Final Comprehensive Field Reconnaissance Report

Demicks Lake Pipeline Right-of-Way
McKenzie County, North Dakota

Project B1904193 (Activity 1.5)

Re: Comprehensive Field Reconnaissance Report
Demicks Lake Pipeline Right-of-Way
McKenzie County, North Dakota

Figure 1: MP61.1 Example Slope Construction

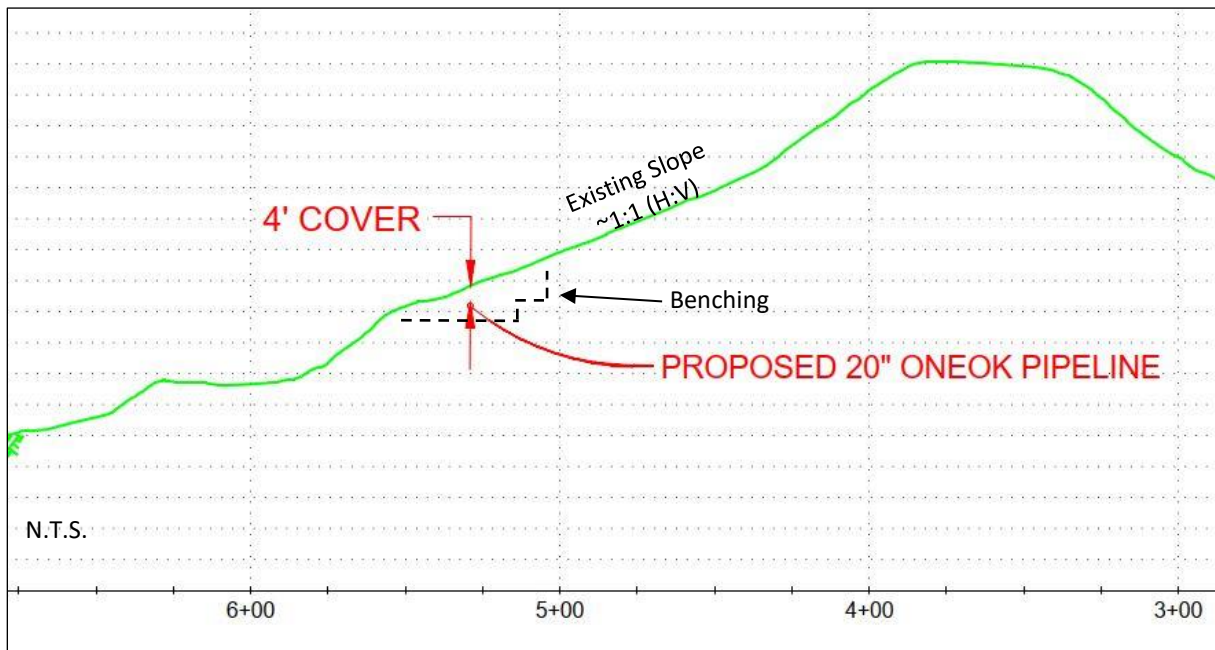
Based on our field observations and construction information provided, there is little concern regarding slope instability at this site. However, similar to MP53.3, care should be taken to not excavate too steeply into the slope and create an unstable situation. Although the native slope of the valley is as steep as 1:1 (H:V) in some locations, we recommend benching the cut slopes to minimize risk of slope instability during construction. Each bench should be less than 4 feet in height. Figure 1 depicts the slope benching technique as described above. The local earth materials are again also highly erodible, warranting long-term slope protection.

The alternative route for this area would be to install the alignment 50 to 100 feet uphill to the east. Since there were no visible signs of slope instability, and the slope is fairly steeper as one proceeds east, we recommend constructing the pipeline in its originally proposed location for ease of construction.

20" DEMICKS LAKE PIPELINE			
NATURAL GROUND PROFILE CROSSING ROUTE @ MILE POST 29.36 MCKENZIE COUNTY, NORTH DAKOTA			
SCALE 1"=50'	PROJECT NO. OPL-008	DRAWING NUMBER OPL008JTAM-MP-88-017	REV. 0

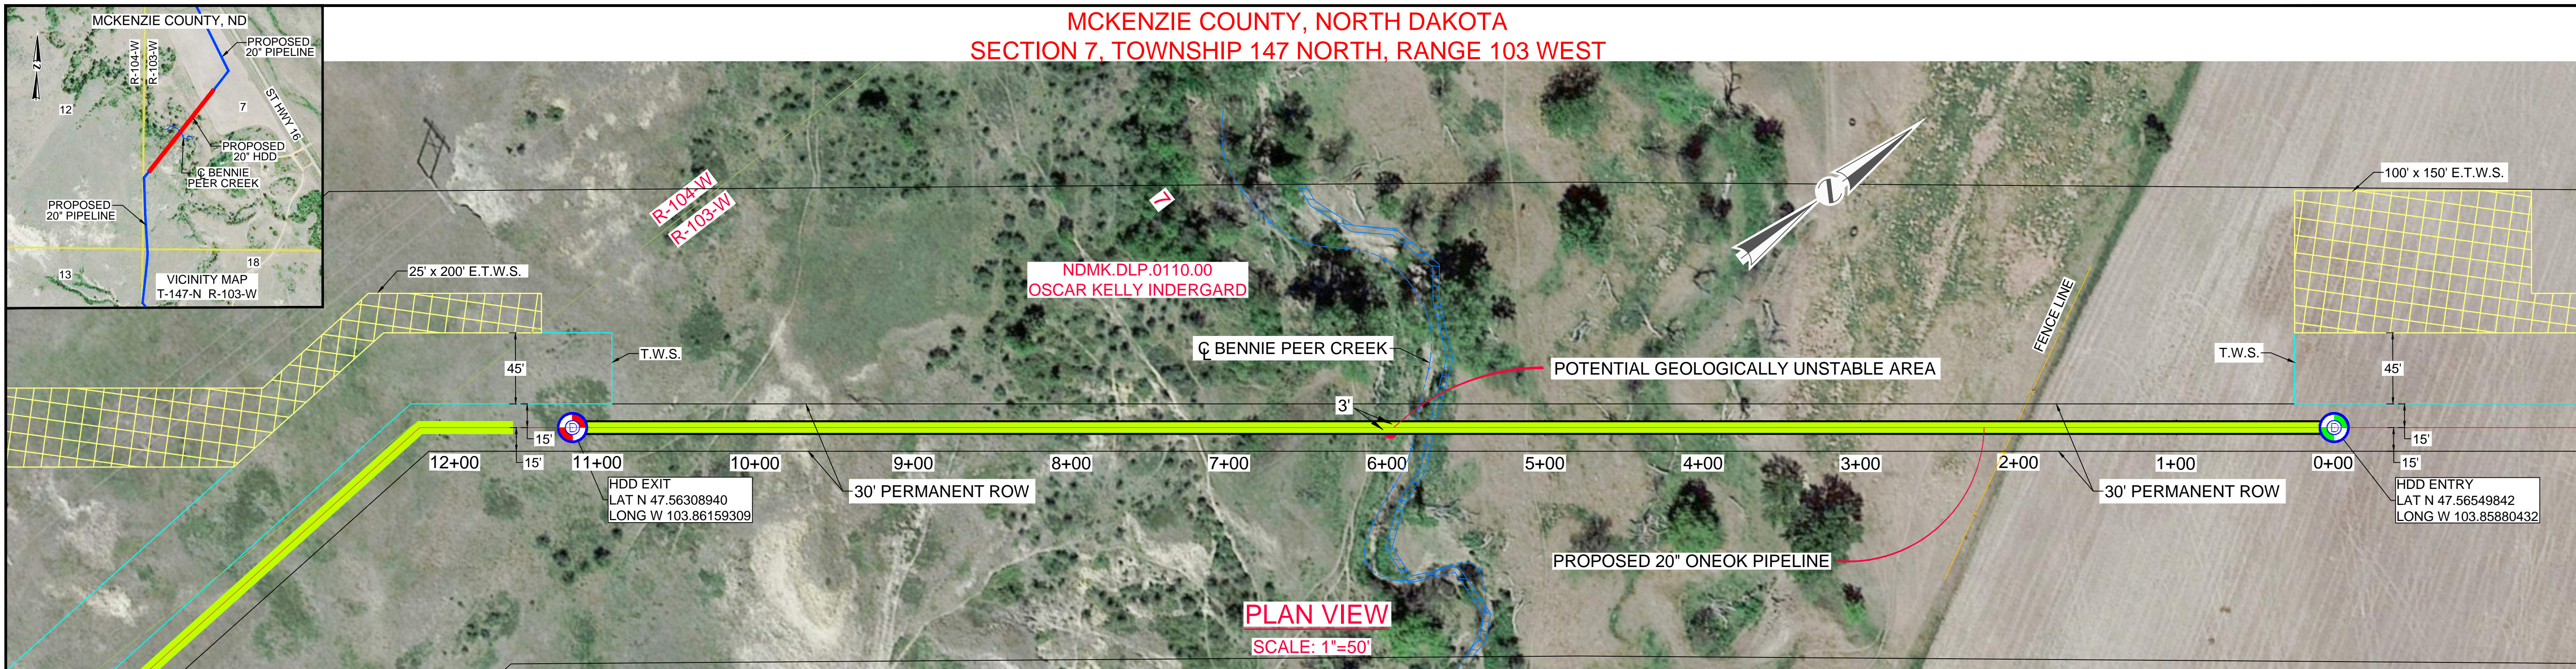
Based on our field observations, and the construction information provided, there is little concern regarding slope instability for open cut installation of this segment of pipeline.

HORIZONTAL DIRECTIONAL DRILL BENNIE PEER CREEK M.P. 59.68 DEMICKS LAKE PIPELINE INDEX #10597			
DES.: EP	AFE#:	DATE: 06/21/19	
DR.: EP		DWG. NO.:	
CH.: CR	SCALE: NOTED		
AP.: CR	CAD#:		
EXHIBIT D			REV. A

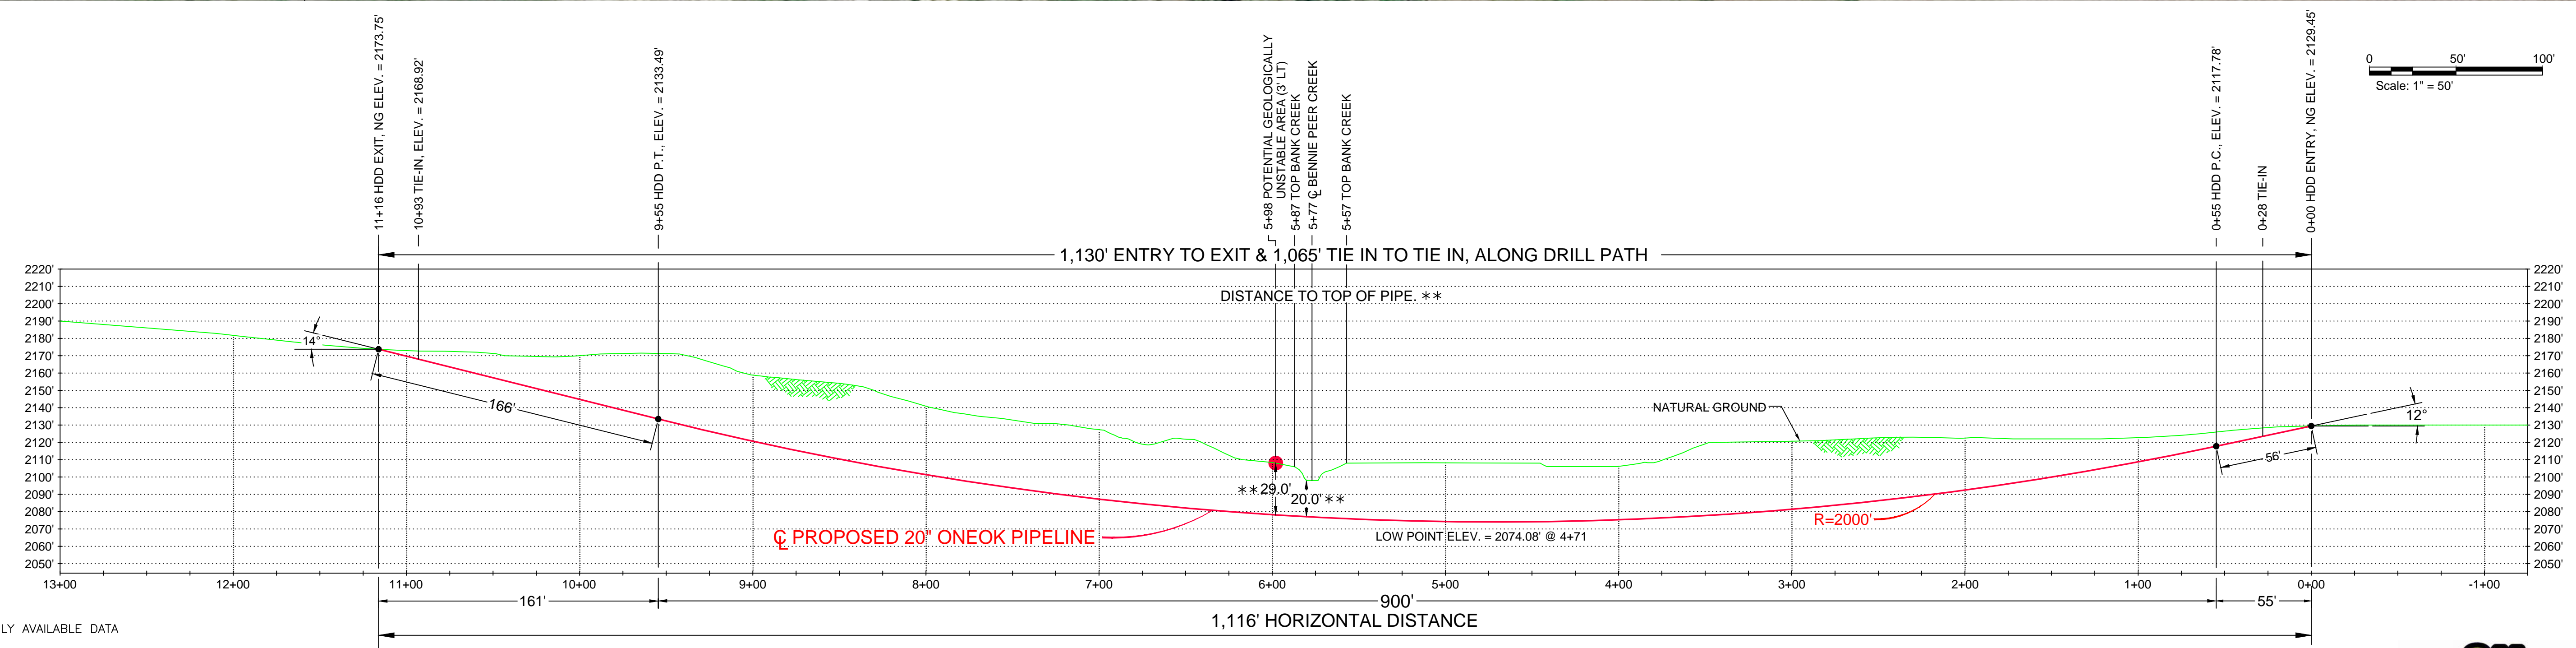
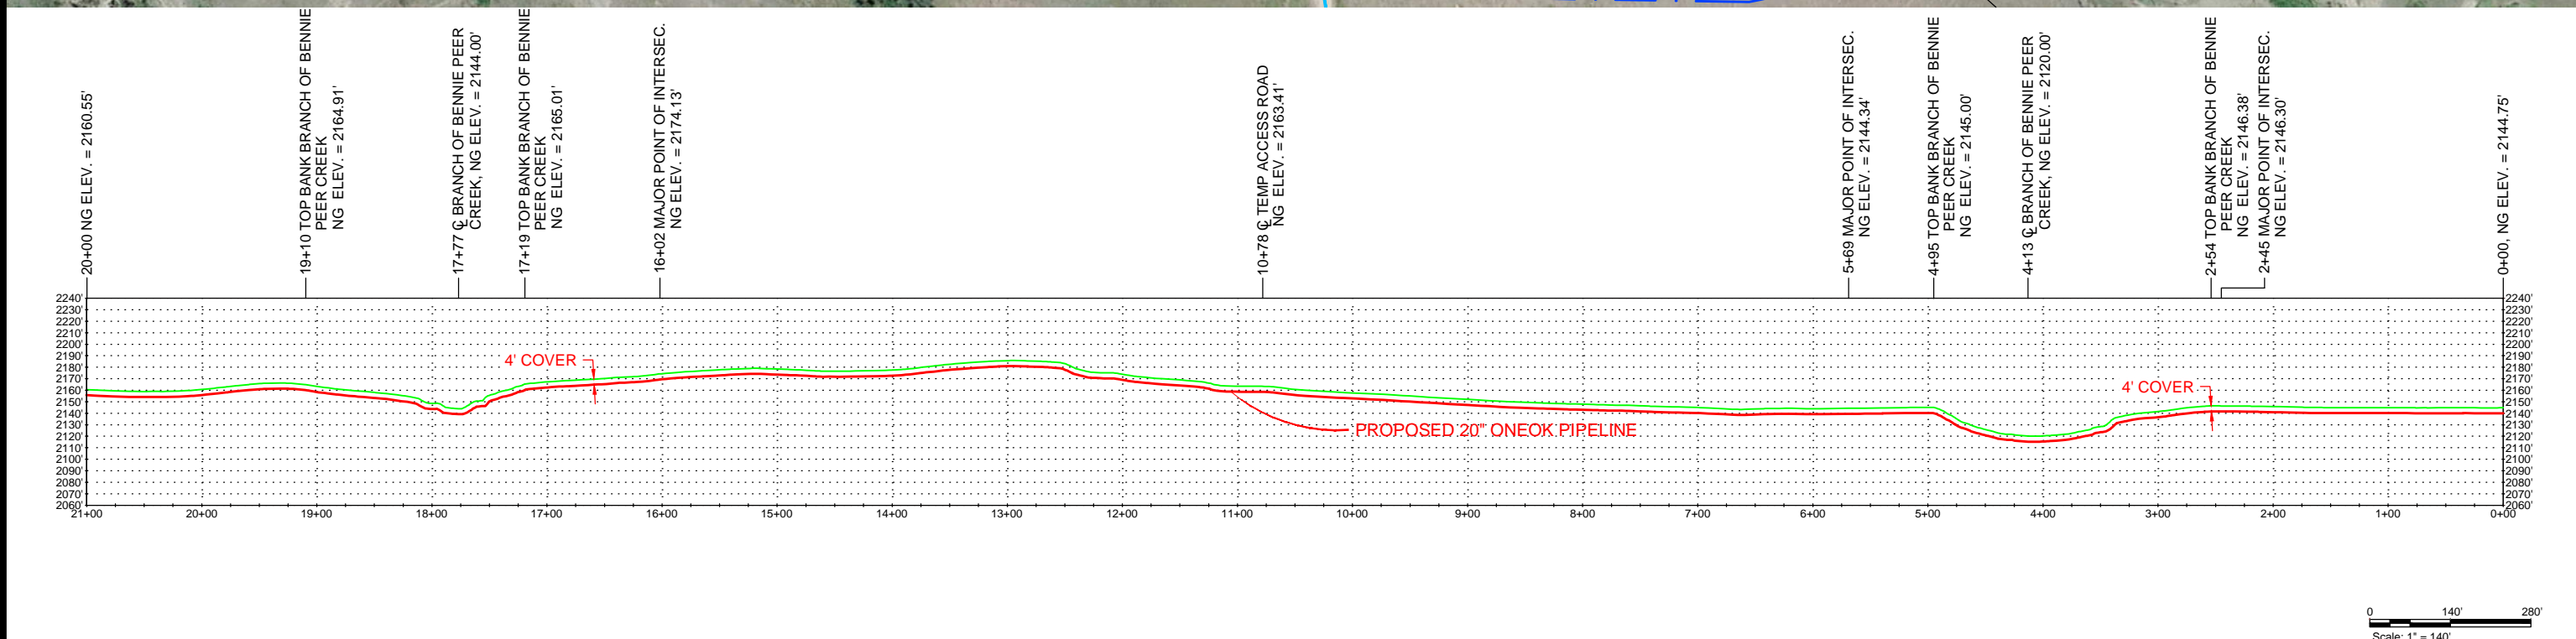
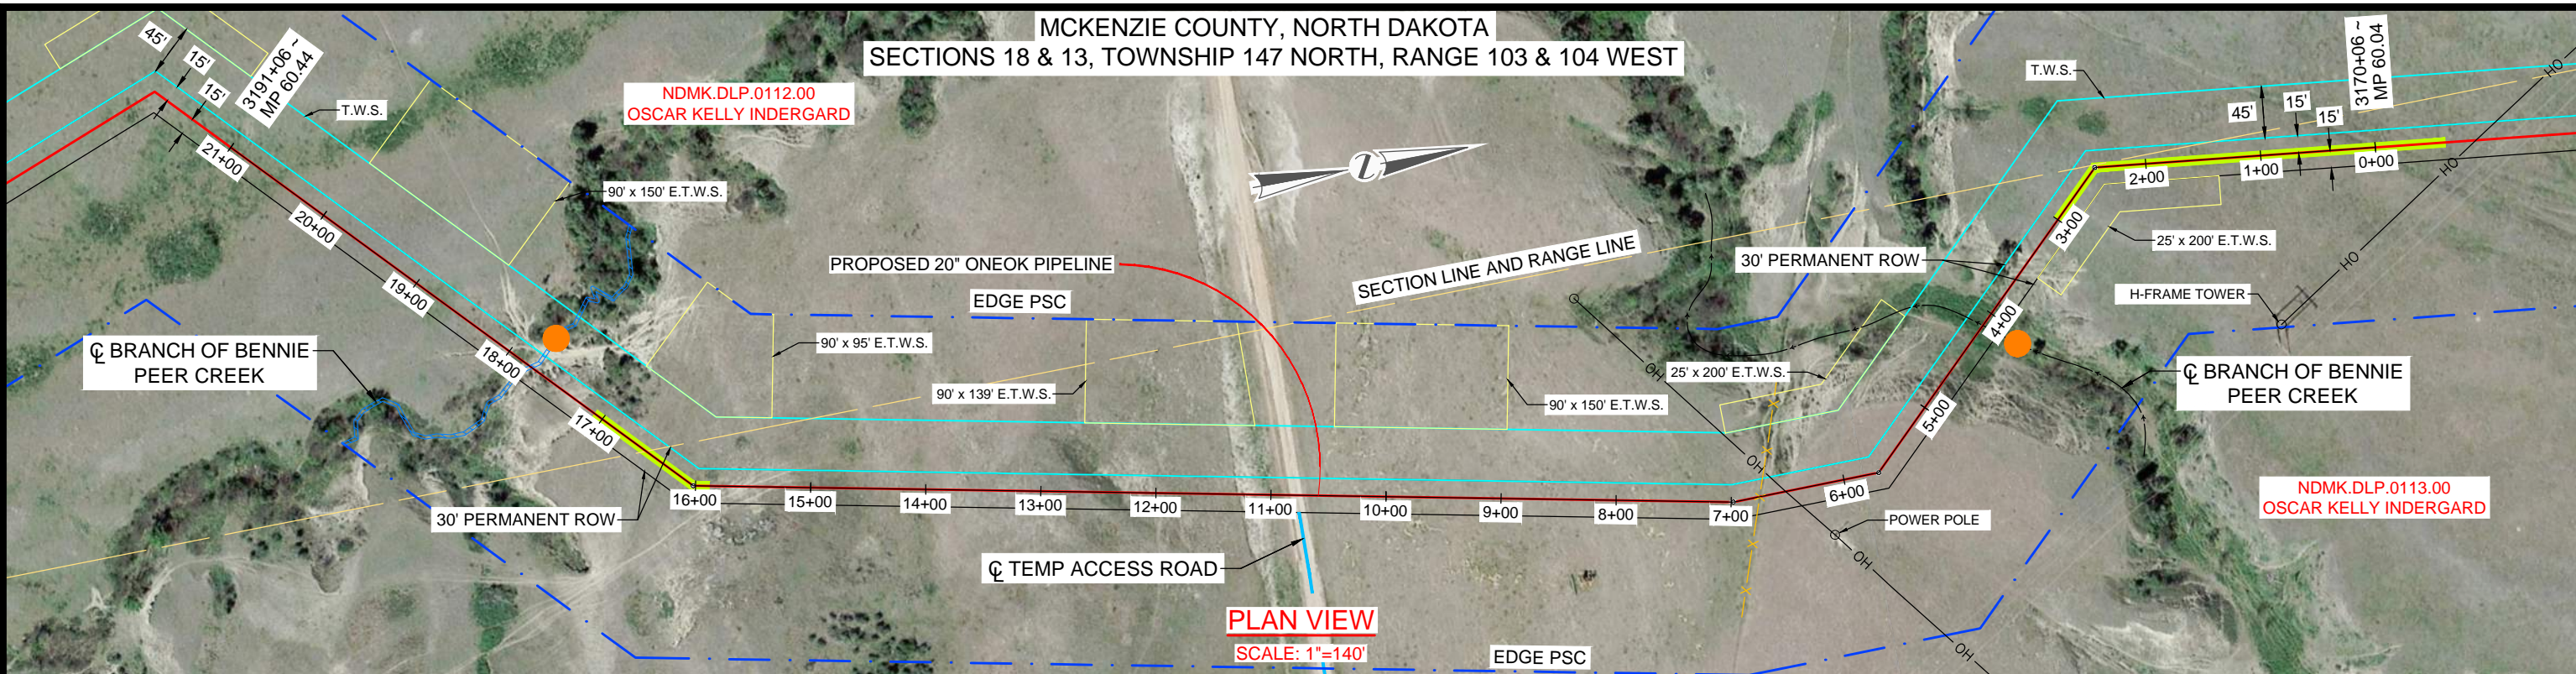
The pipeline near MP59.6 is planned to extend horizontally from northeast to southwest for approximately 1,116 feet. The HDD is planned to cross Bennie Peer Creek. Based on the provided plans, the planned HDD installation depth below the potential geologically unstable area is approximately 29 feet, and a minimum depth of 20 feet is planned below the bottom of the channel. The depth of installation at this location is planned to be about 65 feet. Based on the minimum proposed depth and our field observations, there is little risk of slope instability due to the planned HDD pipeline installation.

20" DEMICKS LAKE PIPELINE			
NATURAL GROUND PROFILE ALONG ROUTE @ MILE POST 60.2 MCKENZIE COUNTY, NORTH DAKOTA			
SCALE	PROJECT NO.	DRAWING NUMBER	REV.
1"=140'	OPL-008	OPL008JTAM-MP-88-021	0

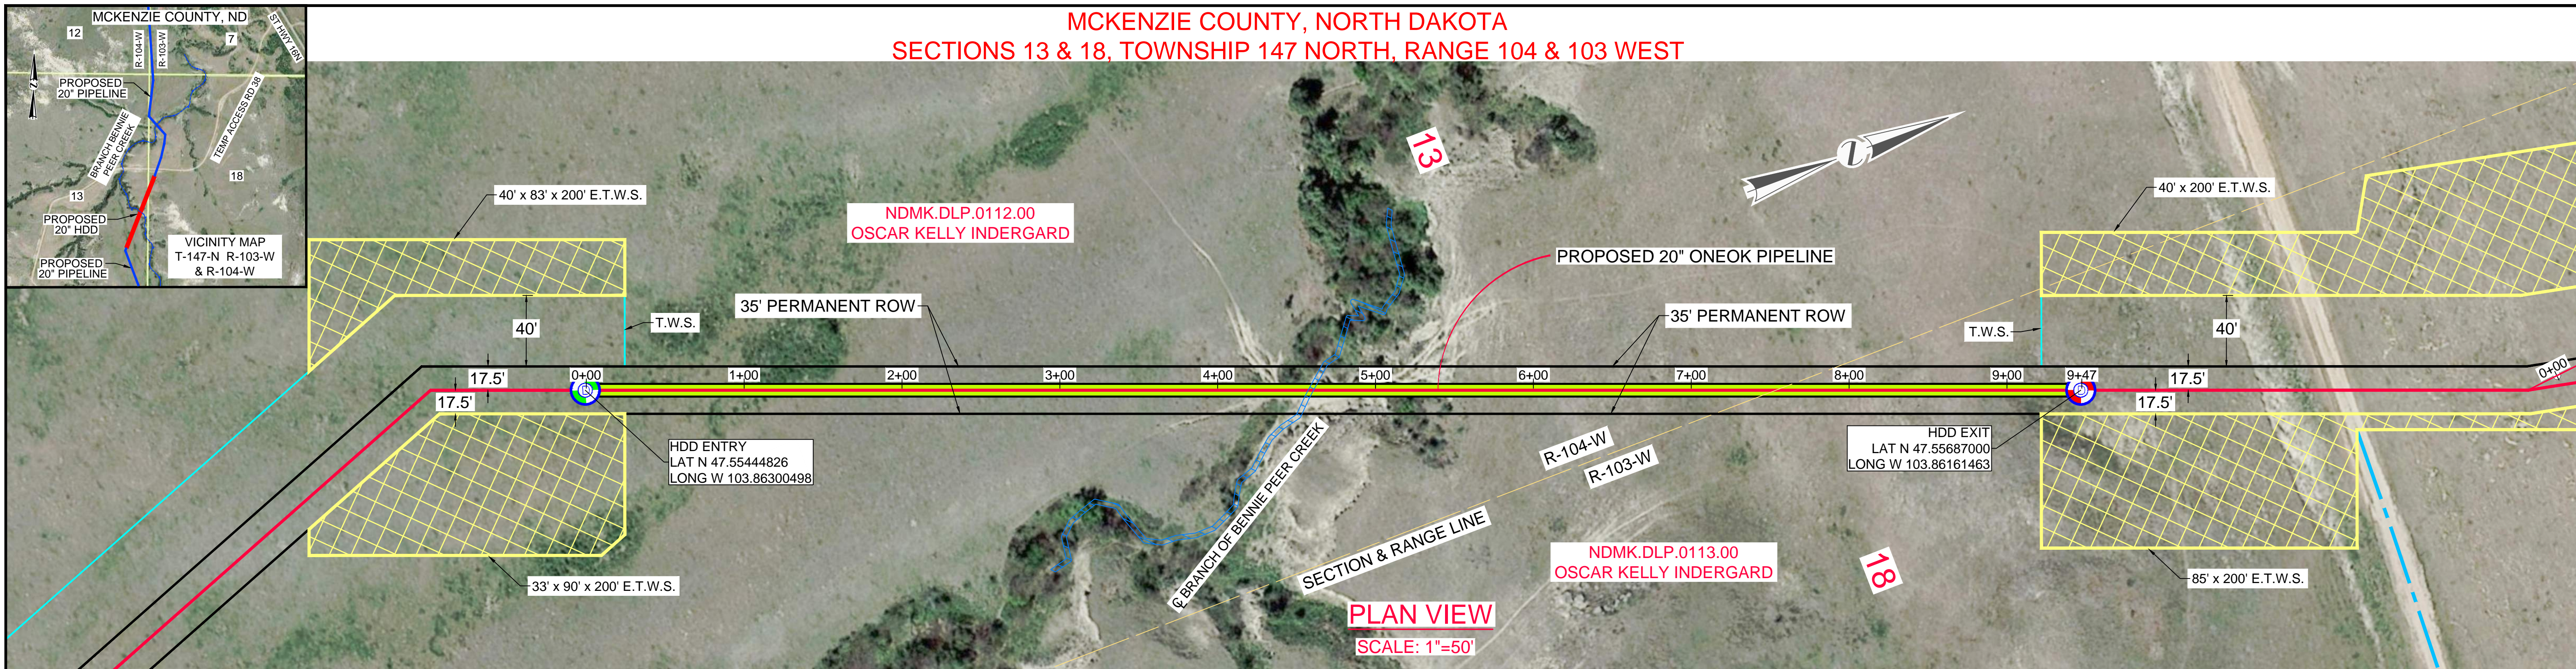
Based on our field observations of the existing valley slopes and provided construction plan/diagram, there is little risk of inducing slope instability due to open cut installation techniques. As the exposed earth materials consisted largely of silt/siltstone, however, we recommend establishing cut slopes at 3:1 (H:V) or flatter.
